AMENDMENT NO. 4

NEERABUP INDUSTRIAL AREA

AGREED STRUCTURE PLAN NO. 17

Structure Plan Ref: WANN/2015/17 - 4

Figure 5

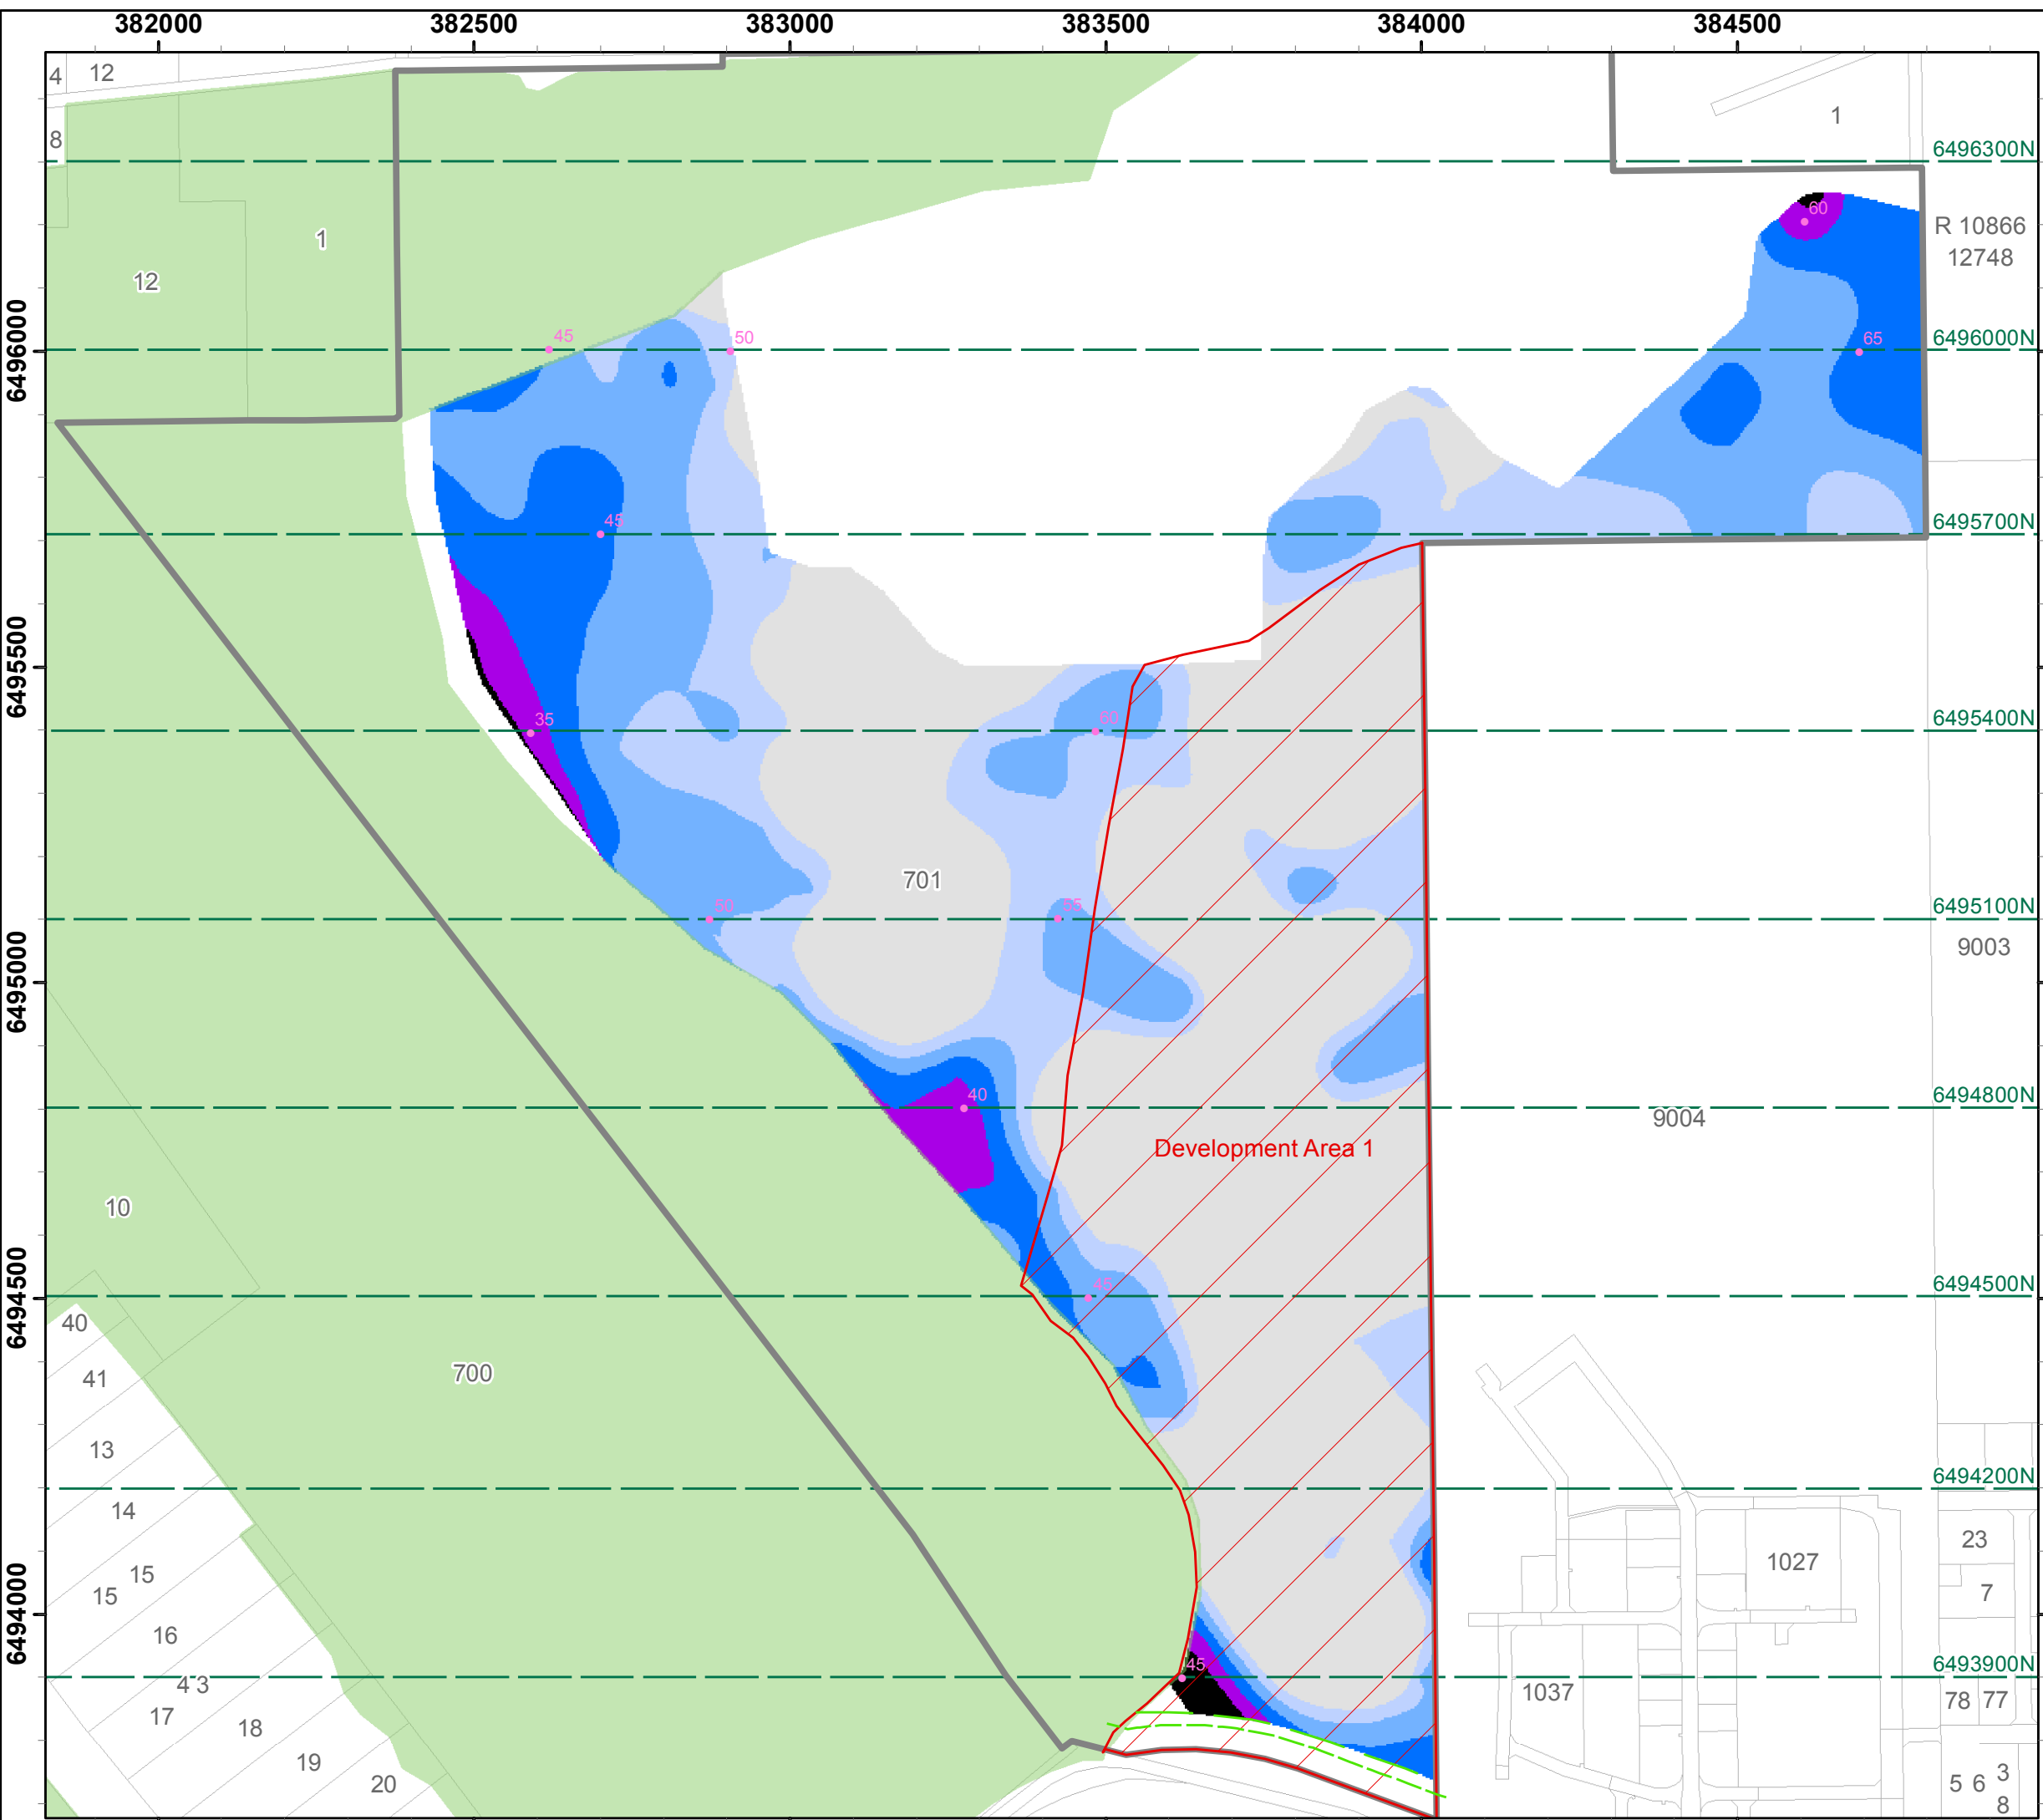
Landcorp is planning for the initial development of 90 ha of industrial land on Lot 701 (refer to figure 5 'development area 1').
